Re: Fill Permit 2017-01 – Windlectric Project

To	Dave MacPherson	Date	February 22, 2017	Project Number	150-3800
CC	Dave Thompson, Loyalist Township Murray Beckel, Loyalist Township Bob Maddocks, Loyalist Township Guy Laporte, G.D. Jewell Engineering Inc. Bryon Keene, G.D. Jewell Engineering Inc.				
Subject	Algonquin Power Amherst Island Wind Project – Fill Permit Application Submission				
From	Dan Fencott

RE: Amherst Island Wind Project
Response to Loyalist Township letter dated February 6, 2017

File: ACCESS ROAD ISLAND DOCK PLAN AND PROFILE
Project No: 131600-00
Scale: 1/4" = 1'-0"
Drawing No: C201

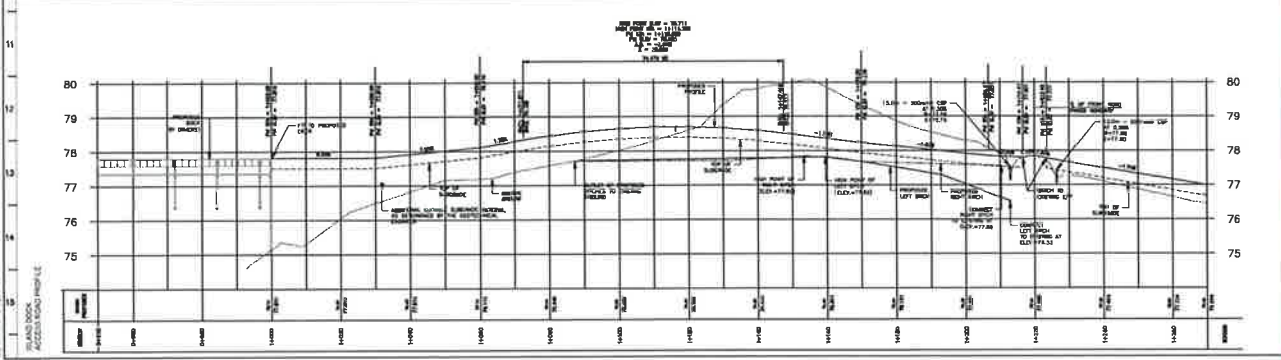
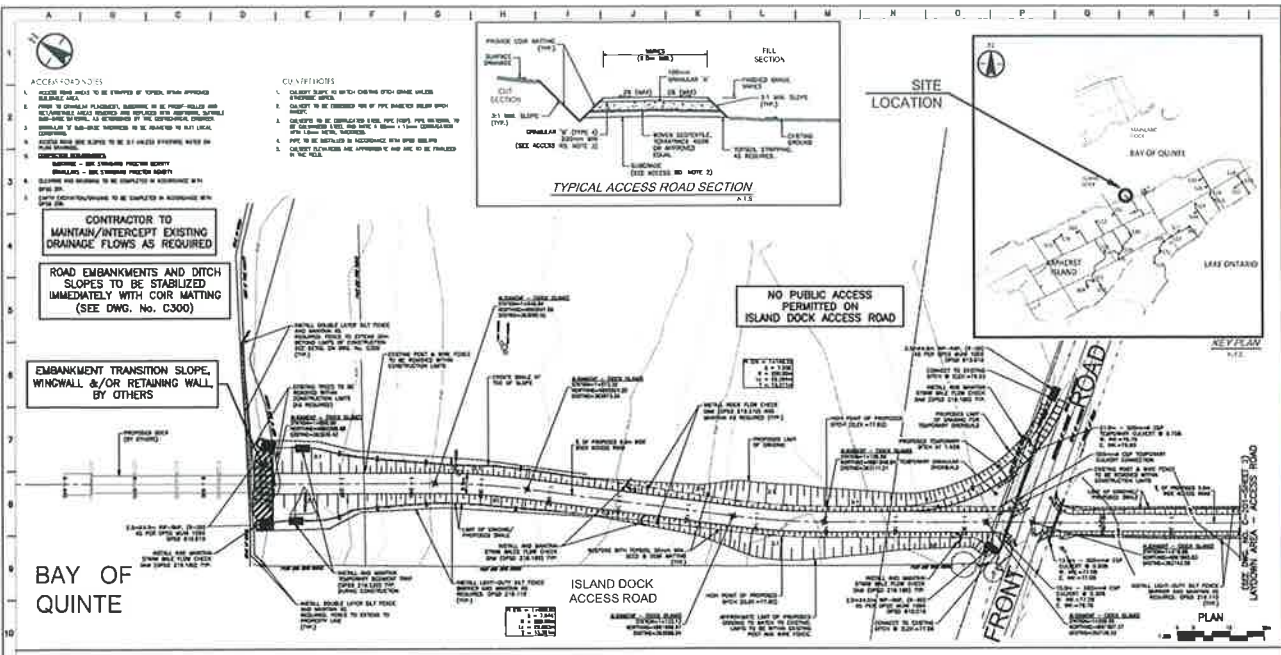
There are drawings included in the application materials for the CRCA, showing the proposed access road and works needed for the Island dock. A second set of drawings is also included in the Municipal package, that are further advanced than the drawings sent to CRCA for approval. The approval drawings (for CRCA) show a 500mm culvert to be placed in the ditch at Front Road. The culvert material is unspecified. In the "For Construction" drawings the same culvert is shown as 400mm CSP. Which size will be installed? How was the culvert sized? Did CRCA provide any review of the proposed culverts on the municipal road? Are they aware of the revised size?

The south culvert at the same intersection is also changed in size between the two sets of drawings. It appears a 400mm culvert is being proposed as per the "For Construction" drawings. Why?

Rip-rap was shown on the entrances and exits of the culverts on the road allowance in the CRCA approval drawings. This rip-rap has been removed in the "For Construction" drawings. Why?

Straw bale flow check dams were initially shown in the CRCA approval drawings, but have been removed in the Municipal application drawings. Why?

The discrepancy between a 400mm and 500mm culvert is the result of a (typographical) error. The entrance culvert for the Island dock parcel should read 500mm. This item has been corrected on the drawing attached to this submission. In addition, the temporary entrance permit, approved by Loyalist Township, notes the correct size of 500mm.

The discrepancy between a 400mm and 500mm culvert is the result of a (typographical) error. The entrance culvert for the Island dock parcel should read 500mm. This item has been corrected on the drawing attached to this submission. In addition, the temporary entrance permit, approved by Loyalist Township, notes the correct size of 500mm. The culvert sizing process is described in the response to question 2, see above.

Although rip-rap is not shown on this drawing, the applications to Loyalist Township for temporary entrance permits do show this detail. These permits have been approved and we understand that the Roads Superintendent has inspected the culvert installation on January 12th and 13th. This application has been submitted for fill activities related to the construction of the access road.

Although straw bales are not shown on this drawing, the applications to Loyalist Township for temporary entrance permits do show this detail. These permits have been approved and we understand that the Roads Superintendent has inspected the culvert installation on January 12th and 13th. This application has been submitted for fill activities related to the construction of the access road.
